## PRODUCT CHANGE NOTIFICATION MAGNETICS

## Non-Shielded Power Inductor Manufacturing Process Change

## Model SDR0604-220YL and SDR0604-470KL

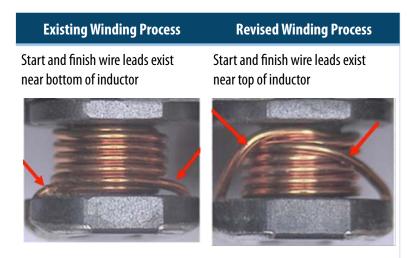
Existing Manufacturing Process Revised Manufacturing Process	
<ol> <li>Manual winding</li> <li>Semi-automated soldering</li> <li>Manual testing, semi-automated laser marking and manual taping (three separate processes)</li> <li>Automated winding</li> <li>Automated soldering</li> <li>Automated testing, laser marking and tap (combined into one process)</li> </ol>	ing

As a result of the winding process change, the form of the inductor will be changed as described below.

The fit and function of these inductors will not be changed. The quality and reliability of the power inductors should be improved as the result of the automation of the manufacturing process.
